**SOLICITATION AMENDMENT
MODIFICATION DE L'INVITATION**

| Title - Sujet Roulotte de chantier | |
| Solicitation No. - N° de l'invitation W7701-186770/A | Amendment No. - N° modif. 003 |

Amendment 003 is intended to answer some industry questions.

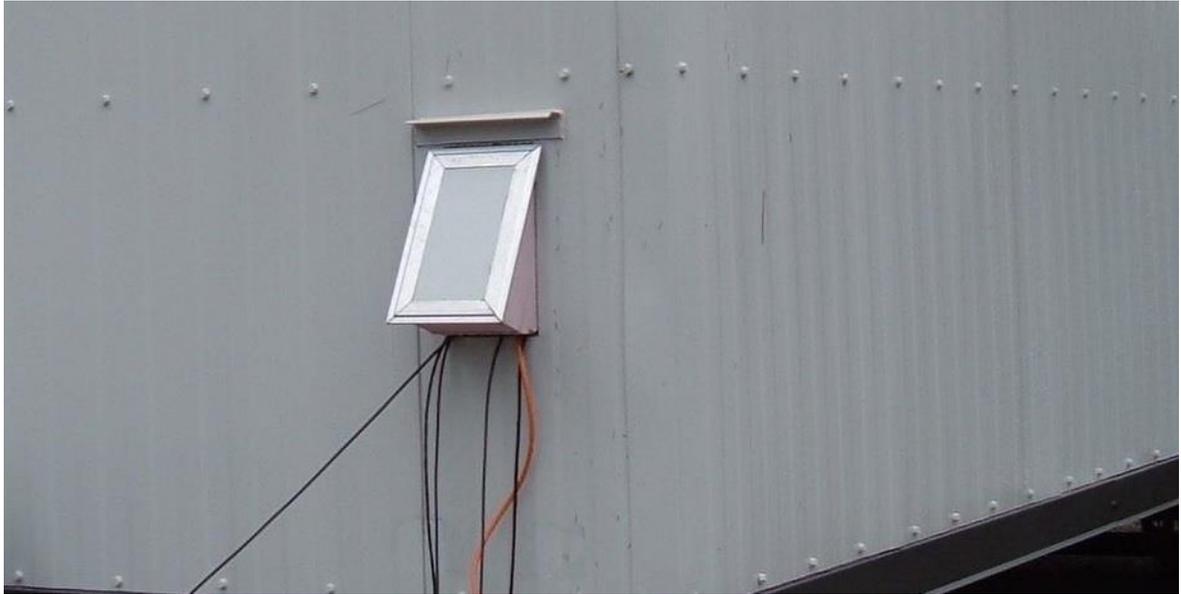
6. What is the preference for interior floor and wall/ceiling finish?
Floor : linoleum
Wall and ceiling : vinyl
7. Section 5.1.11 - Can you provide a picture of the 10x10 inch doors that are required for the passage cables or technical specs on them?
For illustrative purposes only, here are some pictures that show a door for the passage of cables. However, please note that the requested dimensions are 10 x 10 inch.
